Powder River Basin Resource Council

April 23, 2020

Re: Objections to Brook Mining Co., LLC Coal Mining Permit Application & Comments on the Department of Environmental Quality Draft Cumulative Hydrologic Impact Assessment

FIGURE 4.3 PLANNED TRENCH AND COAL BLOCK AREAS WITH FAULTS AND CROSS SECTION LINES

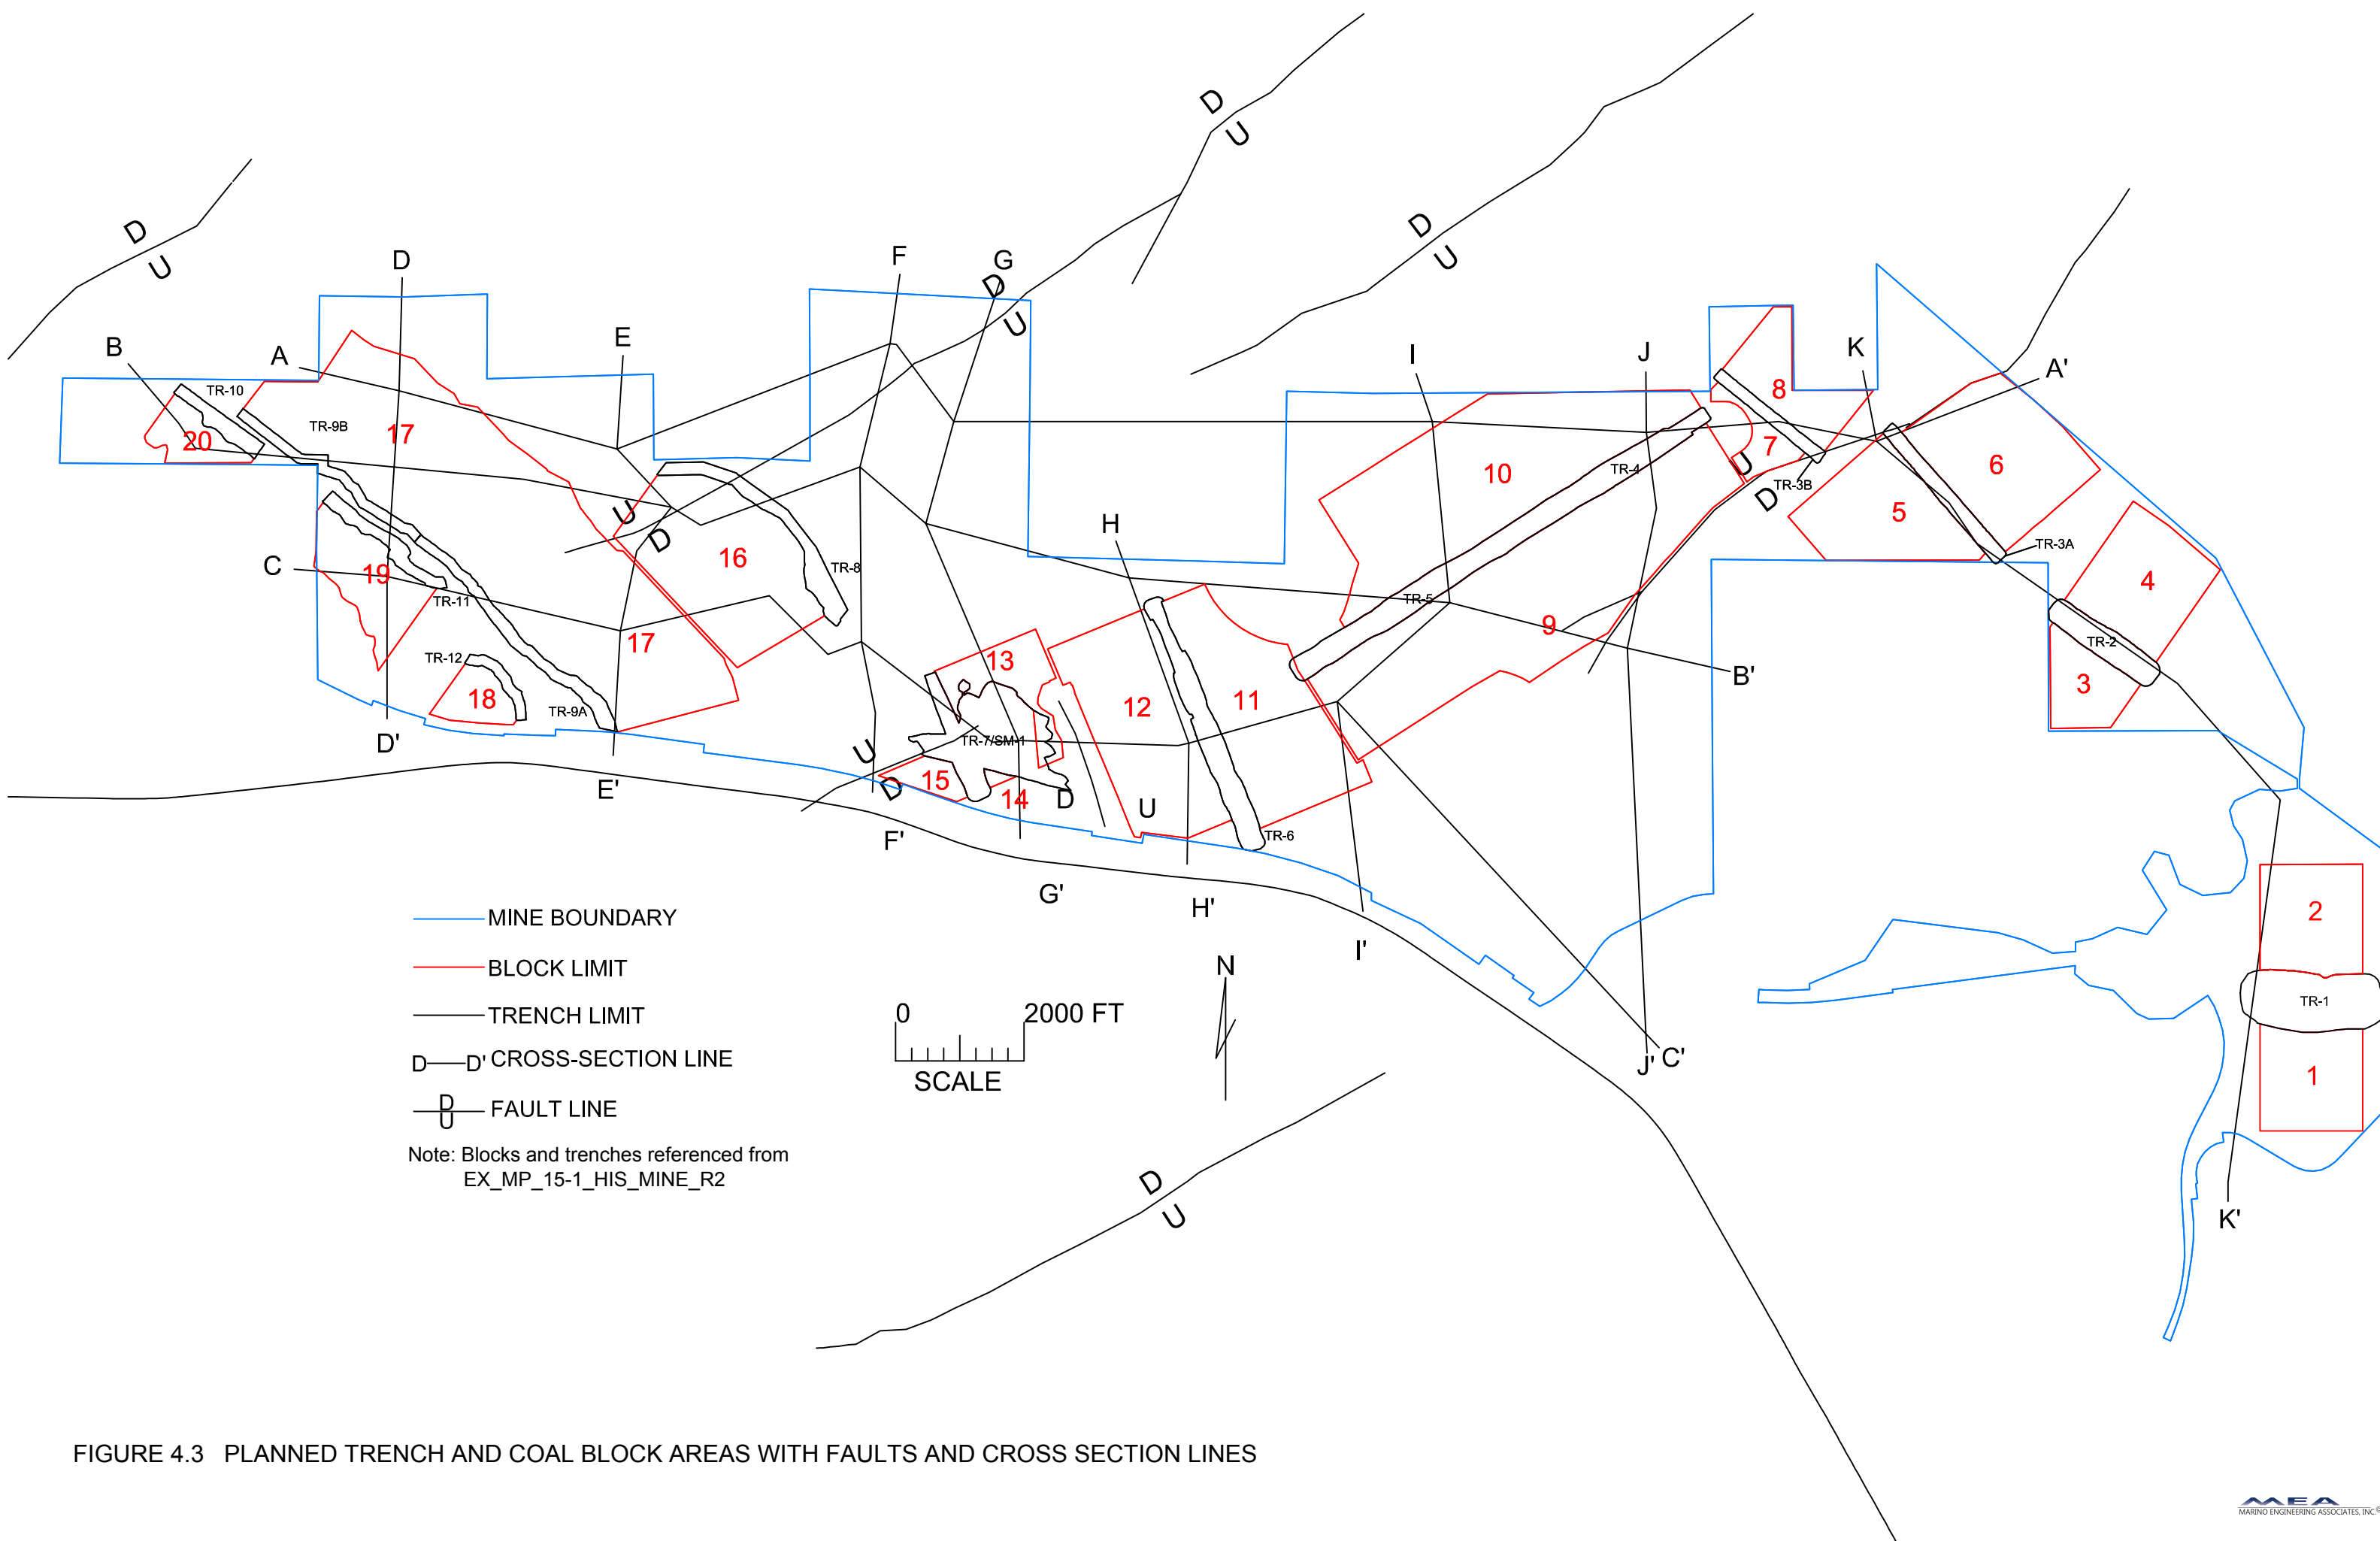
In order to better understand the ground conditions in the areas of proposed mining, the mining layout given in Figure 4.3 has been superimposed over the various isopach exhibits for the Carney and Masters seams provided in the mine application. These drawings are shown in Figures 4.5 to 4.12. Also, the mine block areas had been delineated on the various geologic cross-sections drawn by Ramaco across the site (see Figure 4.3). The modified cross-sections showing the mine block locations are shown in Figures 4.13 to 4.24. From this reported information, the Dietz, Monarch, Carney, and Masters related conditions per block have been summarized in Table 4.1.

FIGURE 4.4 PROPOSED HIGHWALL MINING AND PILLAR CONFIGURATION (SEE P. MP-F3)

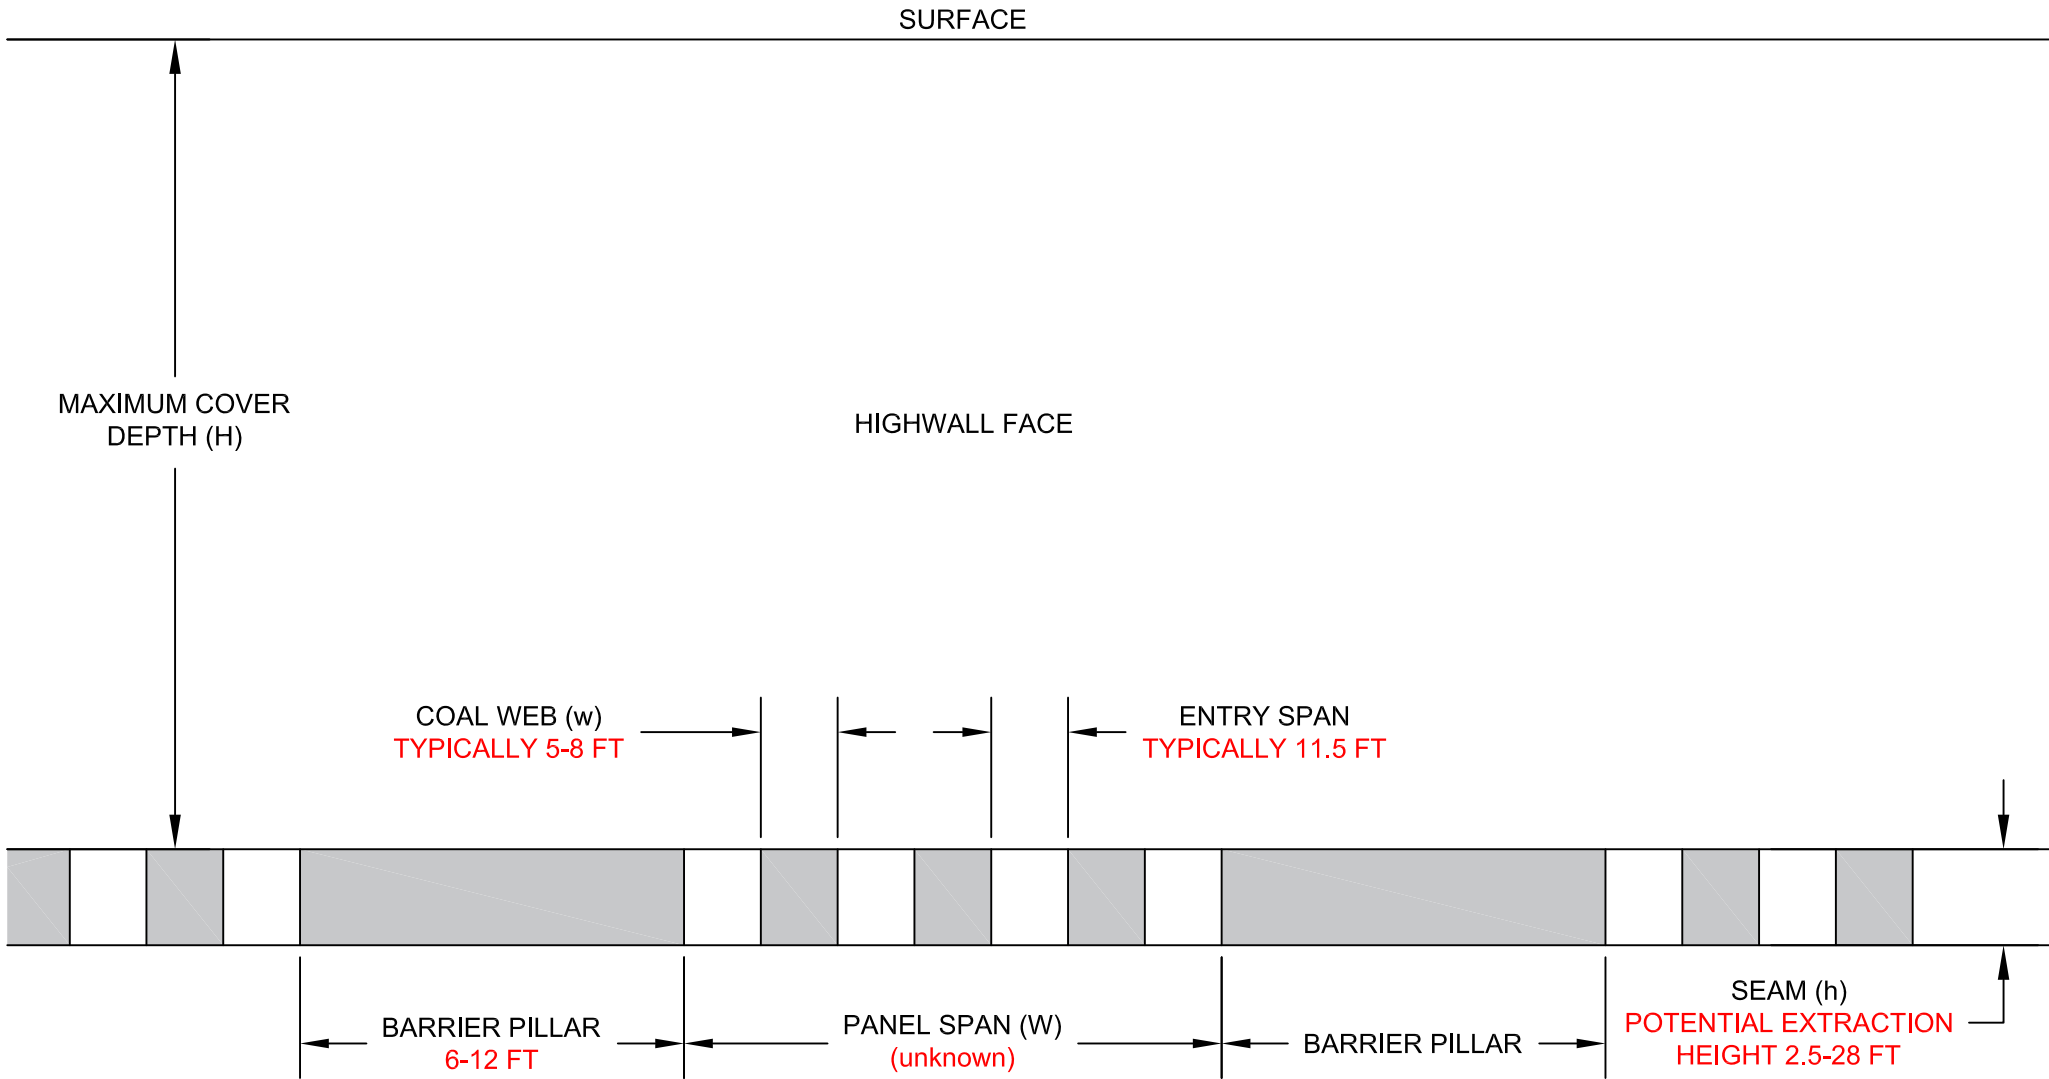
The proposed room and pillar configuration is depicted in Figure 4.4. As can be seen in Figure 4.4, there is no definitive geometry stipulated in the application as much of the identified dimensions are qualified. Using the “typical” web pillar widths and room width, the panel extraction ratio would vary from 59% to 70% in the panels.

FIGURE 7.1 MINE APPLICATION BOUNDARY AND OUTLINE OF VISIBLE MINE SUBSIDENCE OVER EXISTING UNDERGROUND WORKINGS

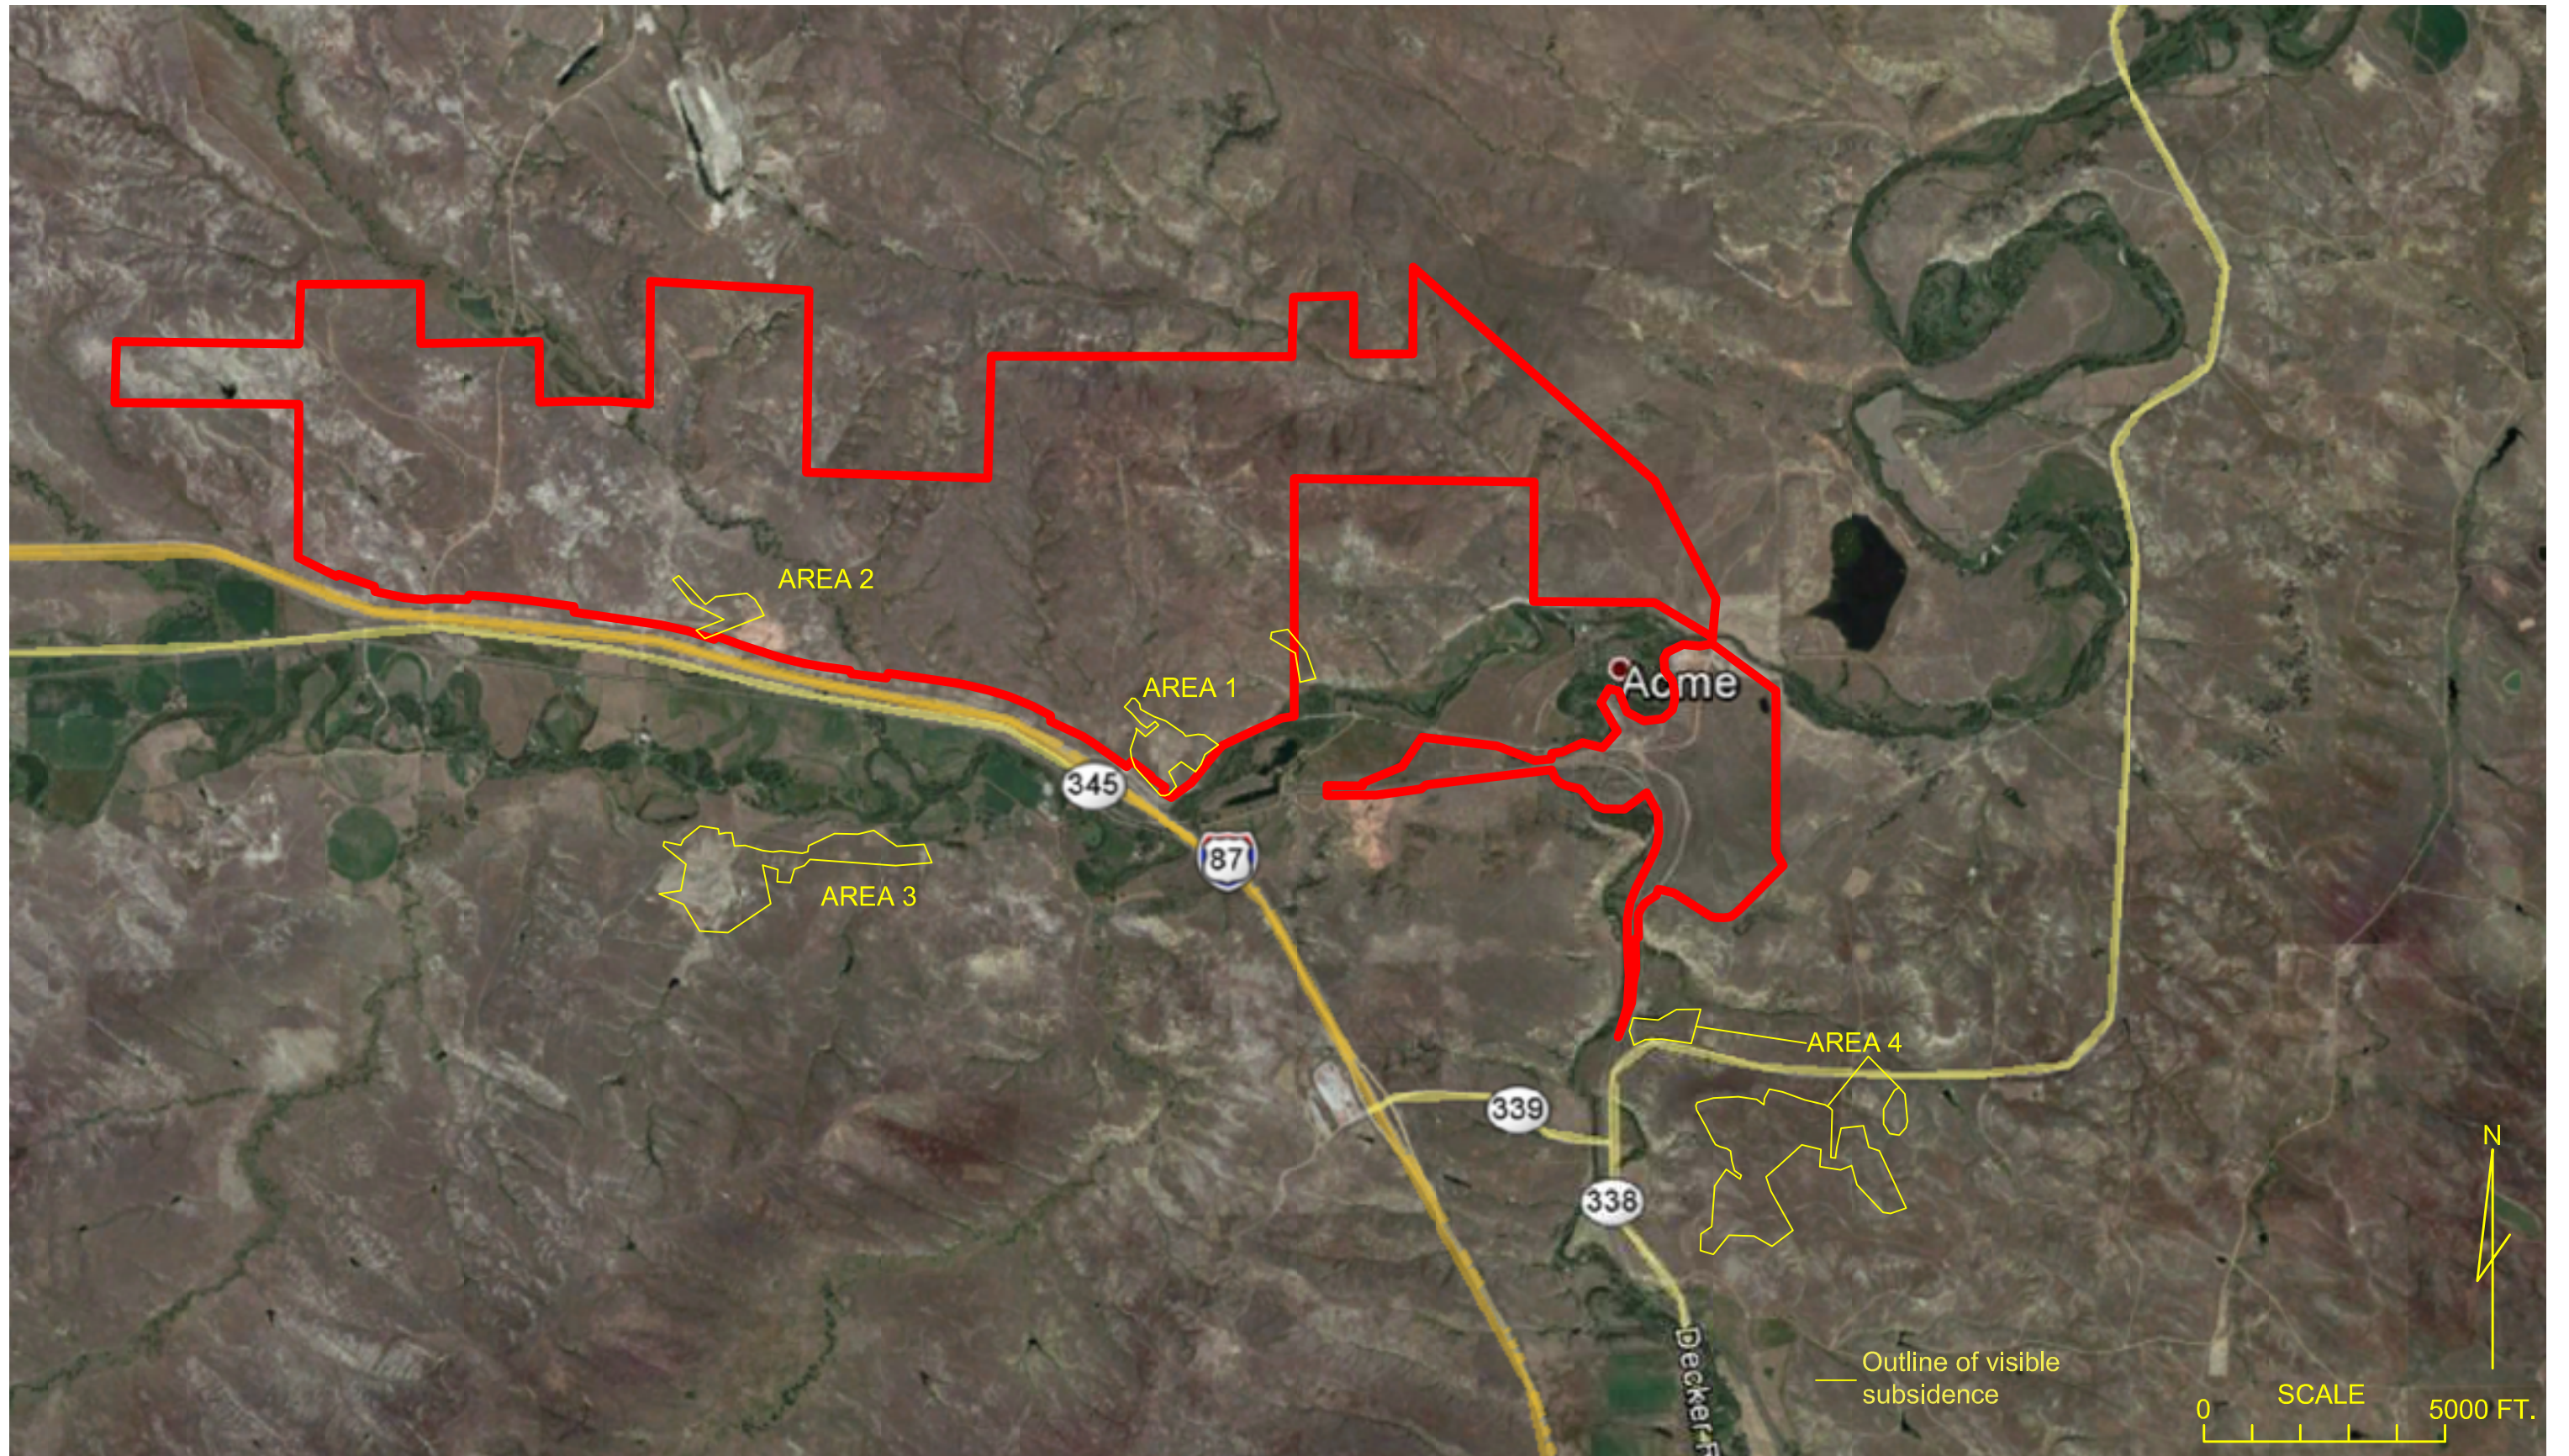
The pit subsidence over the old workings in the mine application area can be seen in the aerial photographs as shown in Figure 7.1 to 7.5. These photographs show areas of more isolated to intense patterns of pit subsidence indicating poor overburden roof conditions. This is consistent with the vast majority of the rock overburden described as claystone without resistant durable interbeds. There also appears to be some subsidence-induced slope instability (i.e. slump features in Area 2, Figure 7.2). The mine depth is estimated to reach up to 160 ft. in visible subsidence areas. Broader subsidence events (i.e. sags) from pillar or pillar bearing failure or mine fire are not noticeable on aerial photographs examined but also are reported in the region.
